Amendments to the Drawings:

REMARKS

The present Amendment is in response to the Examiner's Office Action mailed February 27, 2006. Claim 42 is cancelled, claims 4, 7, 8, 17, 18, 26, and 34 are amended, and no new claims have been added. Claims 1-41 and 43-46 are now pending in view of the aforementioned cancellation.

FIG. 2

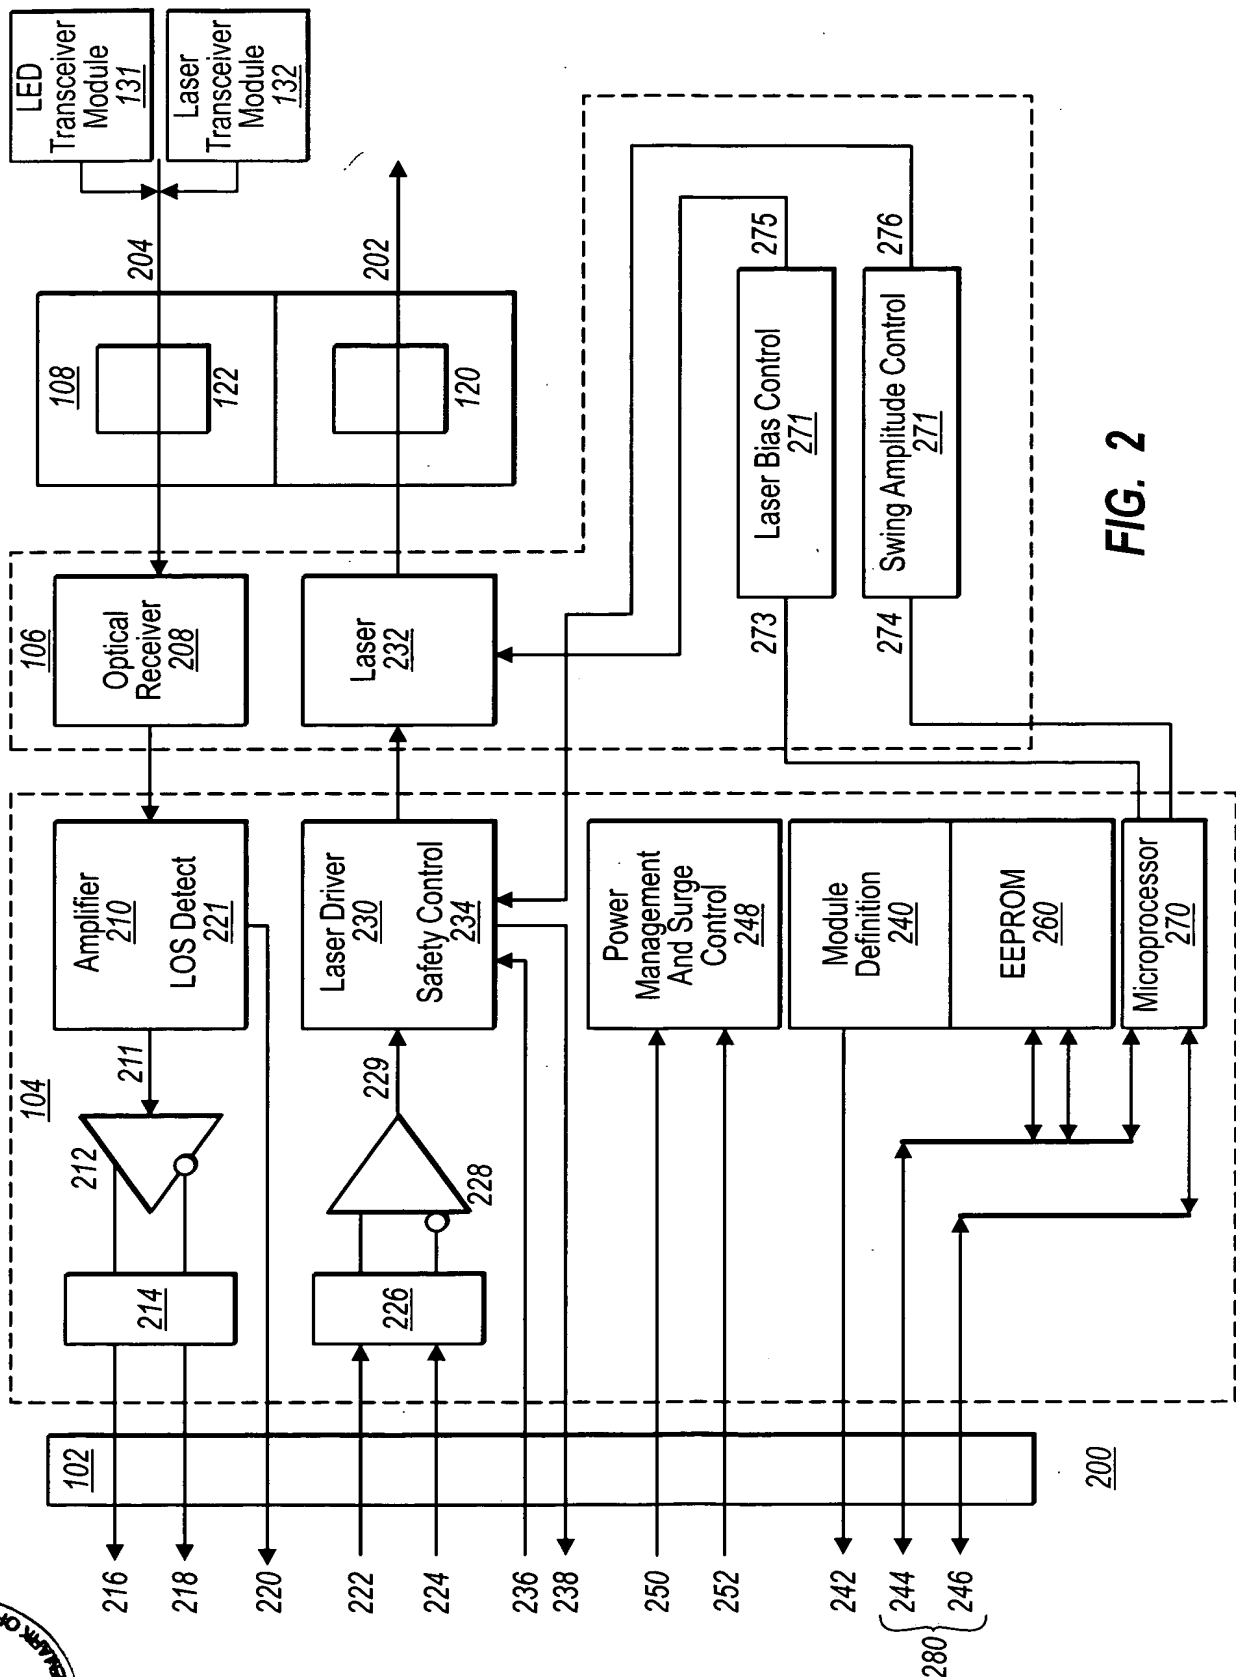
The Office Action in Section 2 objects to the drawings under 37 C.F.R. § 1.83 (a) as failing to show every feature of the claims. Specifically, the Office Action alleges that the "LED

based transmitters” of claims 1, 15, 25, 42, and 43 and the “filtering components for coupling to the optical source” of claims 4, 7, 8, 17, 18, 26, and 34 are not illustrated in the existing figures.

The attached sheet of drawings includes changes to Figure 2. This sheet, which includes Figure 2, replaces the original sheet including Figure 2. In Figure 2, previously omitted elements 131 and 132 have been added.

In response, Applicant has amended Figure 2 to include a laser based transceiver 132 and a LED based transceiver 131. These elements are supported at least by page 2, lines 21-28 and page 11, lines 20-28 of the specification. As mentioned above, Applicant has included a red lined version of Figure 2 showing the amendments to the figure. Applicant believes that no new matter has been added.
